## Service Information No. 11/04

## Replacement of Lubricating Oil and Cooling Water Pressure Switches of Measuring Points 1106 and 2103

**RM43**

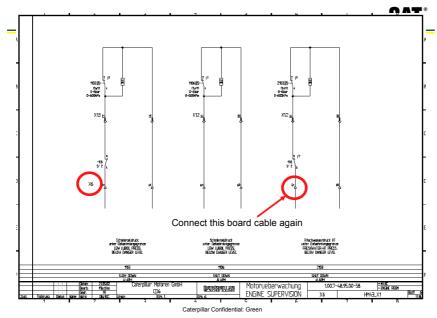
We would like to expressly point out that <u>after</u> replacing the parts the cabling of the cooling water pressure is to be restored to its original condition (please see page 2). With this full operativeness of the monitoring will be reestablished.
